**Montana Fish, Wildlife, and Parks
Bluewater Springs Trout Hatchery Artesian Well Head Development
Addendum # 1**

To: All Plan Holders
From: Cody Wyatt, P.E., WWC Engineering
Date: May 15, 2022
Subject: Addendum #1 – Bluewater Springs Trout Hatchery Artesian Well Head Development

Addendum #1 is hereby written and made a part of the Contract Documents for the above named project.

ARTESIAN WELL HEAD DEVELOPMENT - FLOOR PLAN

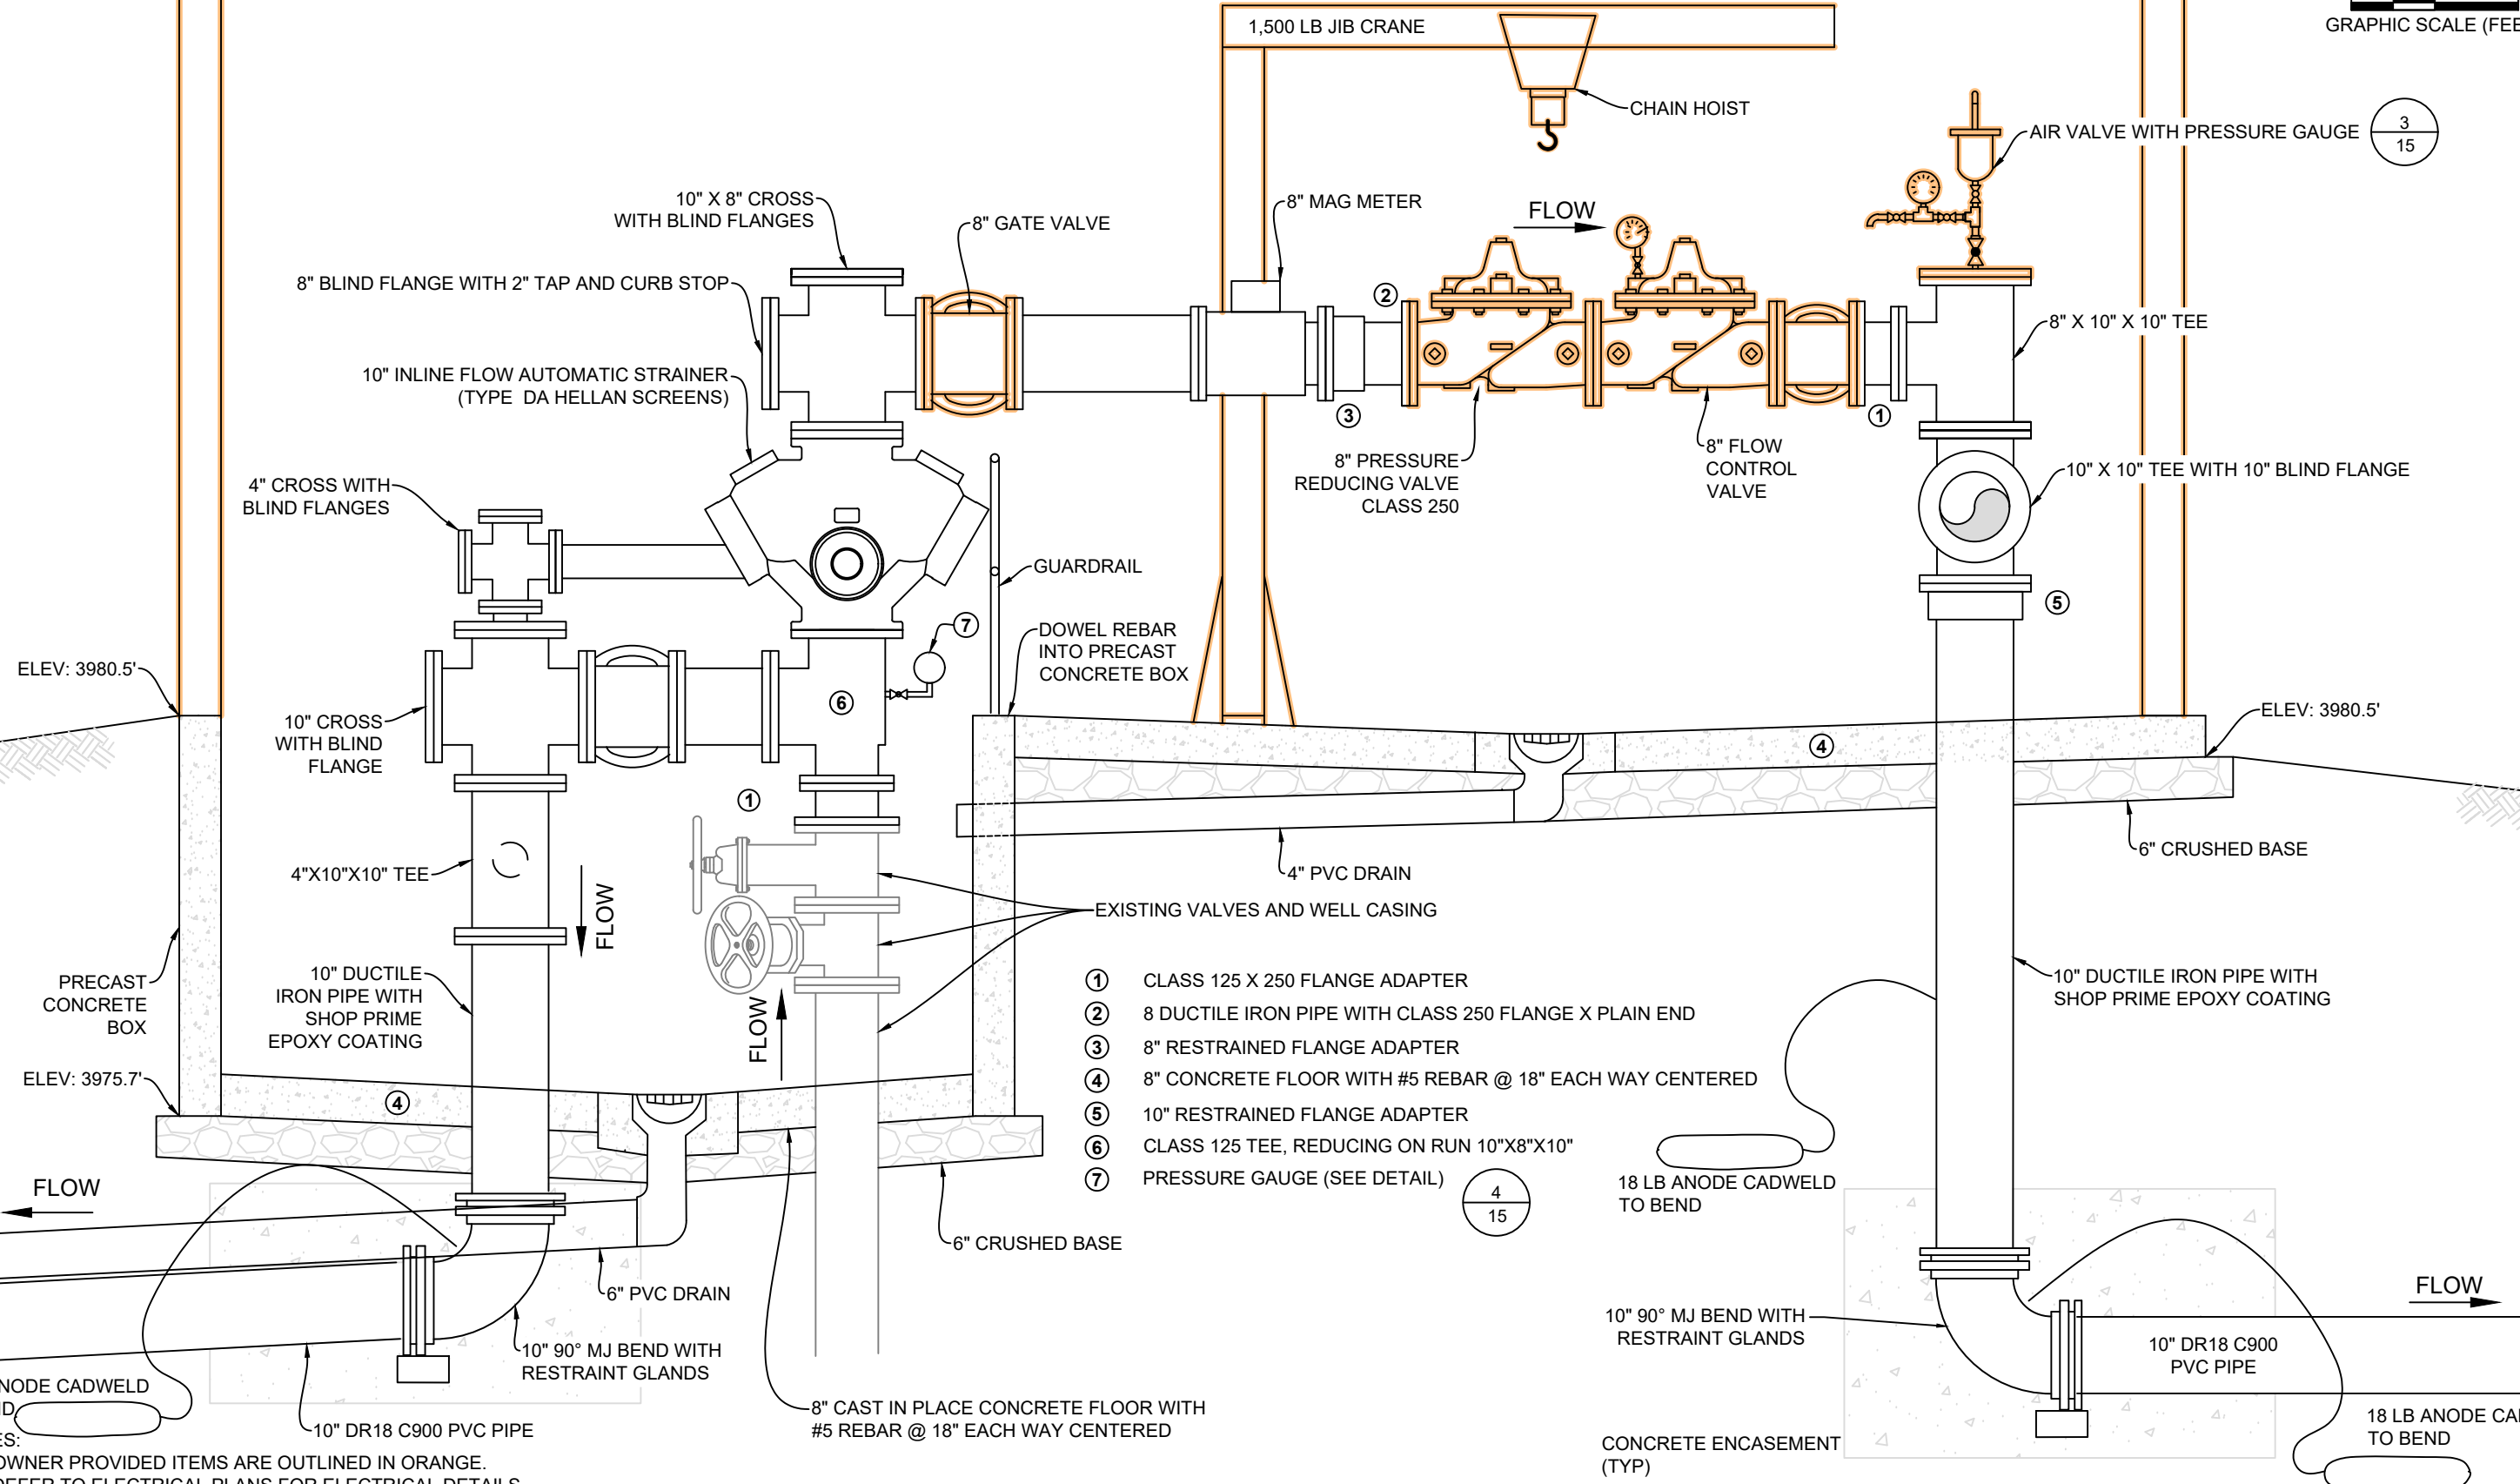
1. There was a discrepancy in the plans regarding the floor slab and vault slab – all slabs will 8 inches thick with #5 rebar at 18 inches on-center.
2. The 10” discharge pipe and 6” drain pipe have been installed by the Hatchery. 144 LF have been removed from Bid Items 9 and 10. Please note that the connection of these pipes will fall under Bid Item 8 and the end treatment of these pipes will fall under Bid Item 9 as described in SP-25.01, Measure and Pay
3. There is not an “American Made” requirement for materials on this project.
